Release Note LS-2 VA1 v2.11.24.69

(This version is only compatible with the new HW version – VA1)

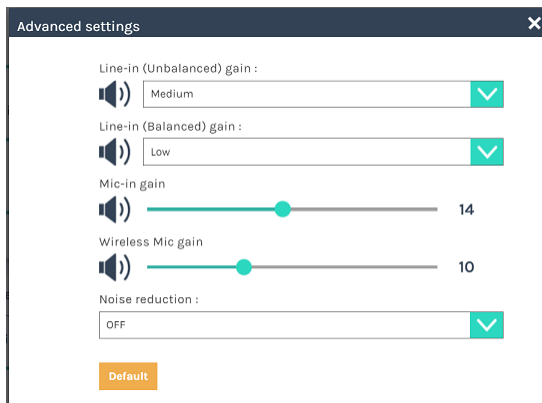
1. Differential audio input with phoenix type connector is “only” available on **LS-300**, **LS-400** and **KL-3T**.
2. Audio Noise Reduction (Line-in/Mic-in)
It can reduce the background noise that is present in recordings.
3. Audio Gain Control (Line-in/Mic-in)
Both balanced (Phoenix) and unbalanced (3.5mm) audio inputs have “Gain Control”.
 - Line-in (Unbalanced/Balanced): 3-step gain – Low, Medium, High
 - Mic-in/BT-Mic: 30-step gain

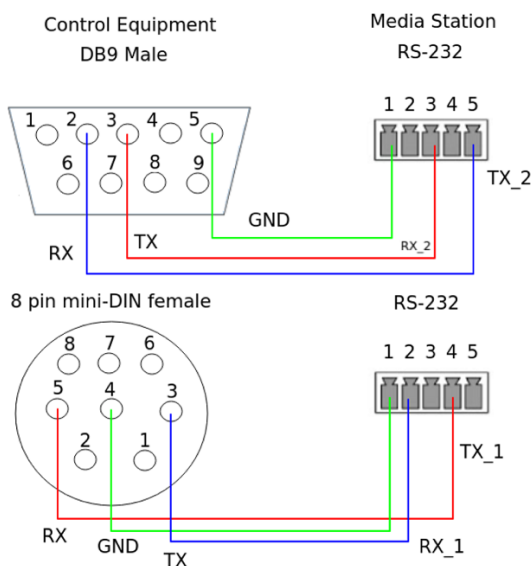
4. Equipped with one RE-232 camera control port
The same RS-232 port can now send commands for camera control while receiving commands from control systems.
* It can only control one camera, for additional cameras, USB-RS-232 cables will still be needed.
